City of Santa Barbara California

STAFF HEARING OFFICER STAFF REPORT

REPORT DATE: July 27, 2016
AGENDA DATE: August 3, 2016
PROJECT ADDRESS: 1210 Shoreline Drive (MST2016-00091)
TO: Susan Reardon, Senior Planner, Staff Hearing Officer
FROM: Planning Division, (805) 564-5470
 Danny Kato, Senior Planner
 Kelly Brodison, Assistant Planner

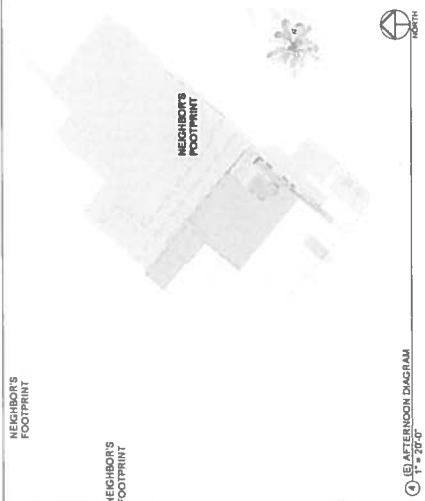
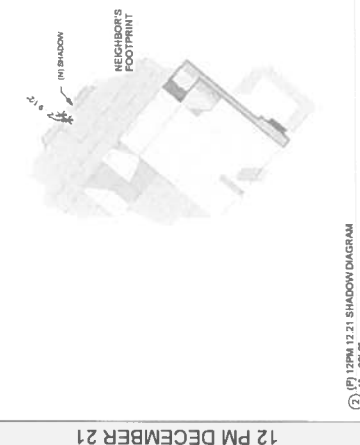
The applicant has provided a shadow study demonstrating that the proposed solar access encroachment will not have significant effect on the adjacent neighbor and the neighbor has also provided a letter supporting the request. Staff has reviewed the plans, and found the project meets all four criteria, and has therefore determined that the Solar Access Ordinance poses an unreasonable restriction on remodel of the existing second story; therefore, Staff recommends that the Staff Hearing Officer approve the request for a modification to the Solar Access Height Limit.

1 APPARENT SETBACK EXHIBIT
1/16" = 1'-0"

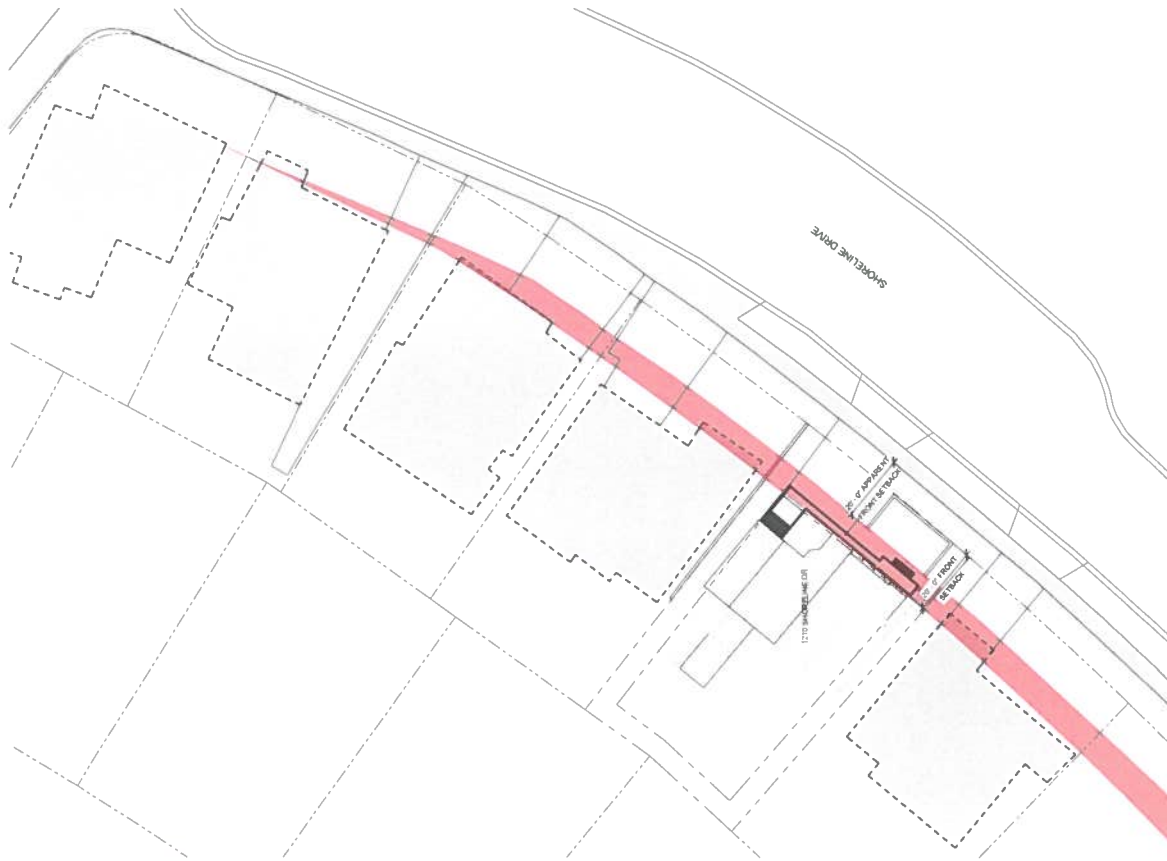
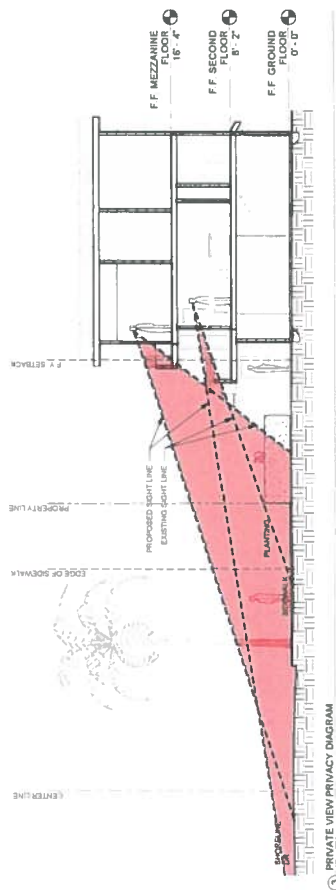
The applicant suggests that this proposal will result in a cohesive design to a deck that is not functional due to the lack of width. Shoreline Park is directly across the street therefore the front setback encroachment will not affect the privacy of neighbors to the south.

Staff is not supportive of any further encroachment into the front setback. The existing house was constructed before the Neighborhood Preservation Ordinance was created and is 3,301 square feet in size on a 5,796 square-foot lot, which is 125% of the required FAR. Staff believes that a reasonable remodel could take place on the property without further encroaching into the front setback and therefore recommends that the Staff Hearing Officer deny the request for the Front Setback Modification.
